# Q-313

## Transit Upfitter Switches Modification (Make Hot-At-All-Times)

2020 Model Year Transit equipped with Upfitter Switches

#### Auxiliary Fuse Panel and Relays

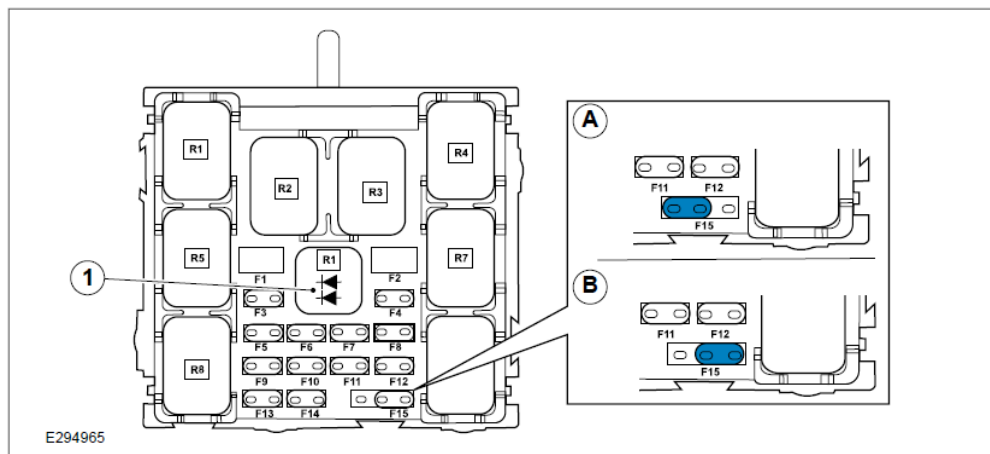
The 2020 Model Year Body and Equipment Mounting Manual (BEMM) contains an error relative to the Body Builder upfit switches.

In prior model years a relay bridge was used to make Auxiliary switches 1,2, and 3 hot-at-all-times. For 2020 Model Year this has changed. In order to make these switches hot-at-all-times fuse # 15 in the Auxiliary fuse box must be moved to the secondary location as shown in the diagram below.

Item	Description
A	Ignition Only position of F15
B	Permanent Power Only position of F15
1	Diodes (1A rated) - Make sure the diodes are orientated correctly or they will not work

The diagram shown on page #161 in the 2020 BEMM is correct but the verbiage located on page #169 is incorrect and applies to Model years 2019 and previous only. Please disregard this text and use the diagram found on page #161
